### NOTICE TO ALL CONTRACTORS:

<p><b>Proposal #13: 4327-08-71</b> <b>V Denmark, CTH R</b> <b>Devils River Trail Bridge B-05-0438</b> <b>CTH R</b> <b>Brown County</b></p>	<p><b>4327-09-71</b> <b>V Denmark, CTH R</b> <b>Wall Street Bridge B-05-0439</b> <b>CTH R</b> <b>Brown County</b></p>
--	---

### Letting of January 14, 2020

This is Addendum No. 01, which provides for the following:

Addendum No. 01  
ID 4327-08-71  
Revised Sheet 60  
January 8, 2020

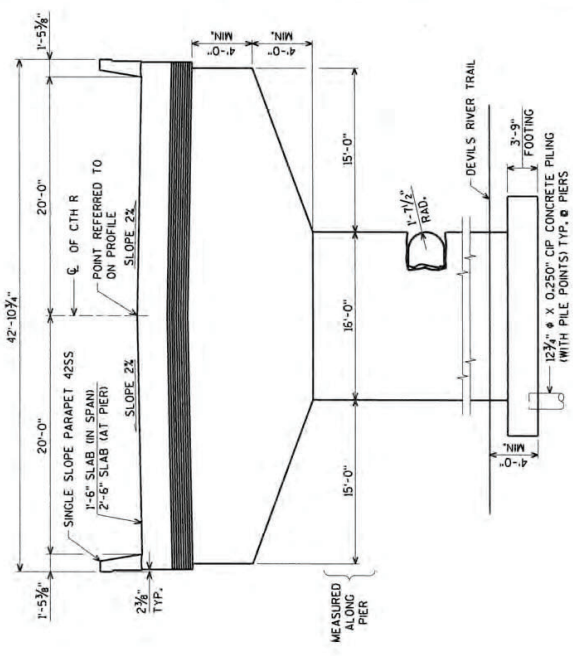
Revised Plan Sheets	
Plan Sheet	Plan Sheet Title (brief description of changes to sheet)
60 (60)	Quantities, Typical Section, & Design Data (Revised quantity for Pipe Underdrain 6-Inch for project 4327-08-71)
10 (98)	Miscellaneous Quantities (Added items Removing Small Pipe Culverts and Removing Concrete Slope Paving for project 4327-09-71)
69 (157)	General Plan (Revised Slope Paving for project 4327-09-71)
70 (158)	Quantities, Typical Section, & Design Data (Revised quantity for Pipe Underdrain 6-Inch and Slope Paving Concrete for project 4327-09-71)

NO.	DATE	REVISION	BY
01-20		ADD PIPE UNDERDRAIN AT SLOPE PAVING	AYRES

Addendum No. 01  
ID 4327-09-71  
Revised Sheet 69  
January 8, 2020

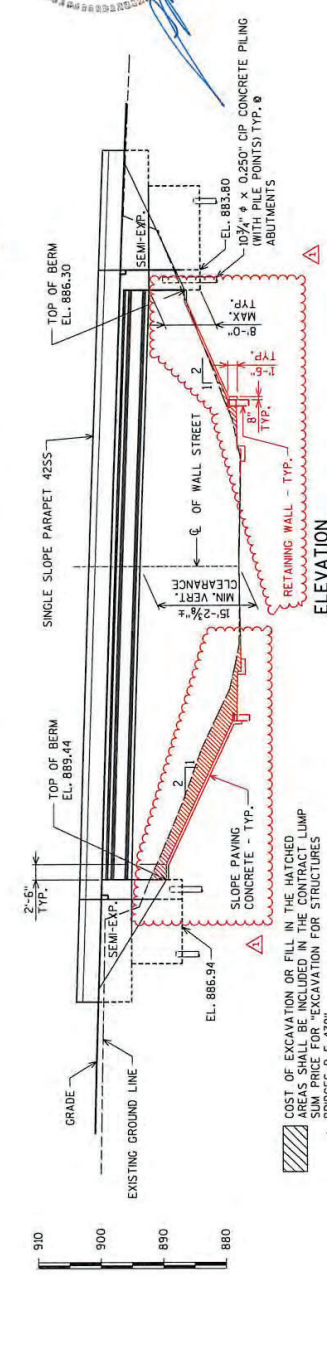
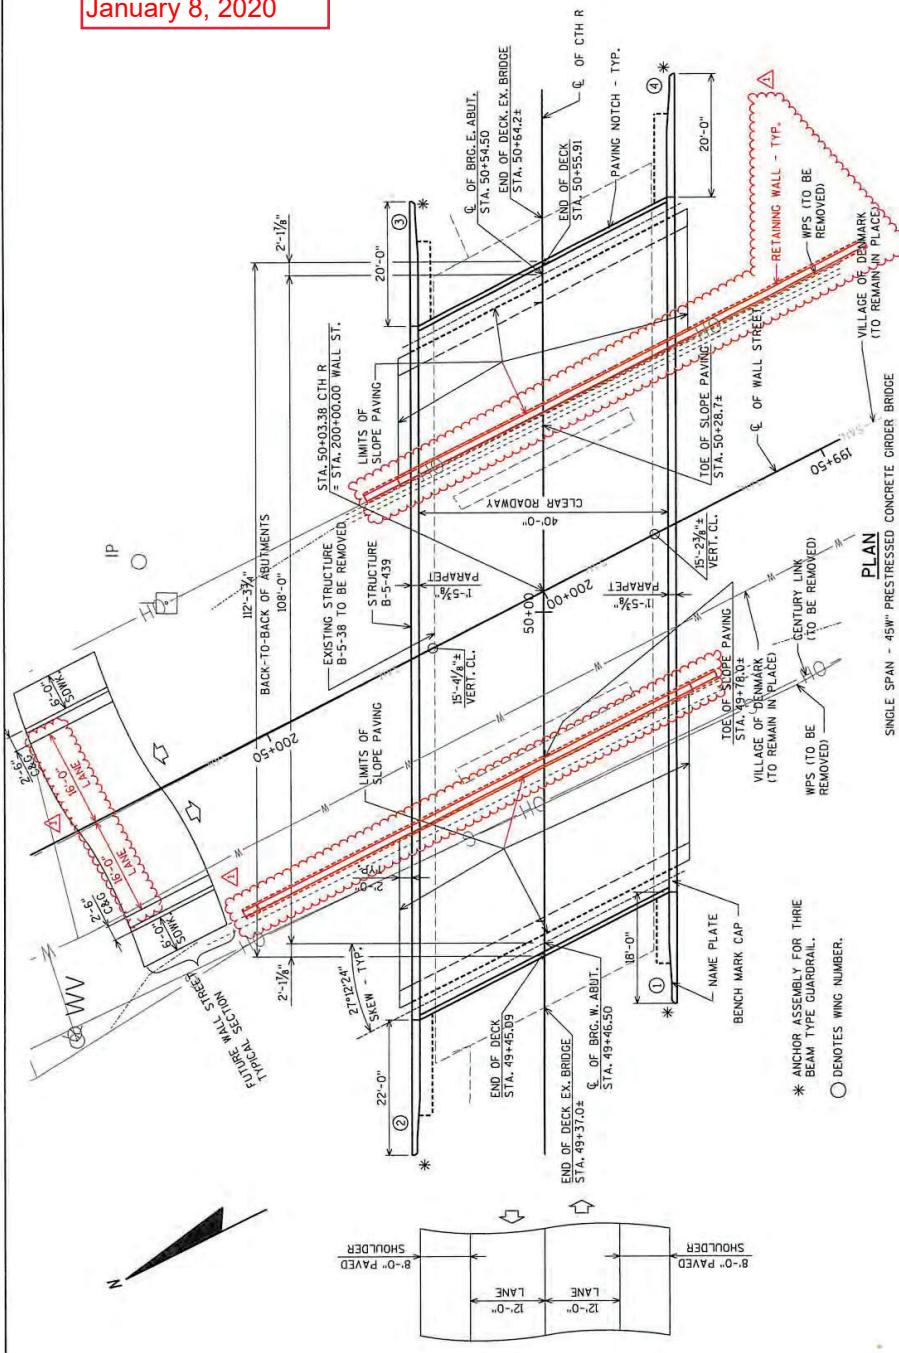
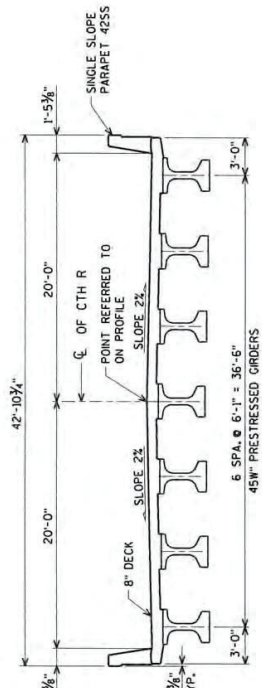
NO.	DATE	ADD	REVISION	WALLS	AYRES	BY
8

Addendum No. 01  
 ID 4327-09-71  
 Added Sheet 96A  
 January 8, 2020

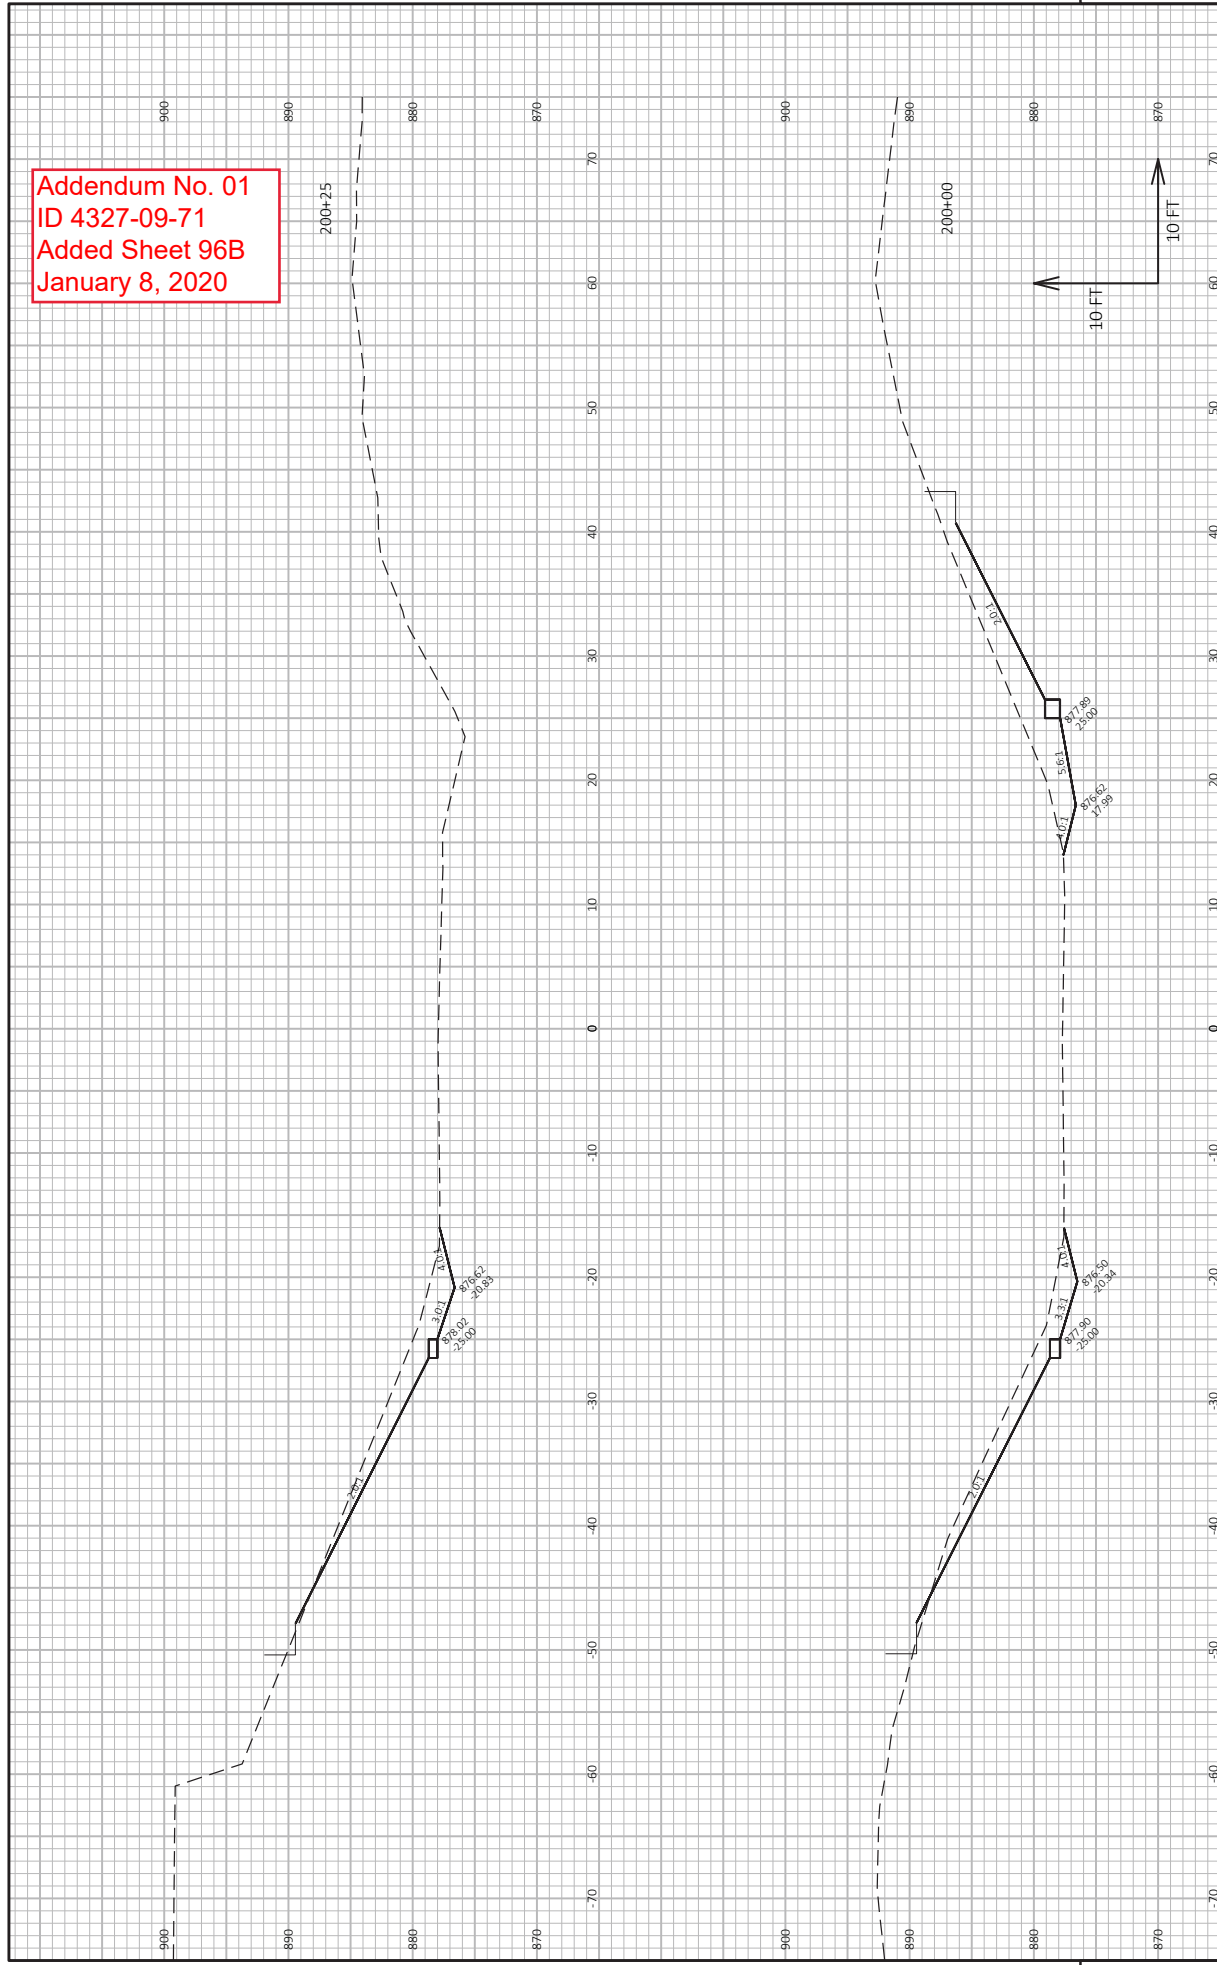
<b>Added Plan Sheets</b>	
<b>Plan Sheet</b>	<b>Plan Sheet Title (brief description of changes to sheet)</b>
96A	Cross section sheet under Bridge B-05-0439 along Wall Street
96B	Cross section sheet under Bridge B-05-0439 along Wall Street
96C	Cross section sheet under Bridge B-05-0439 along Wall Street
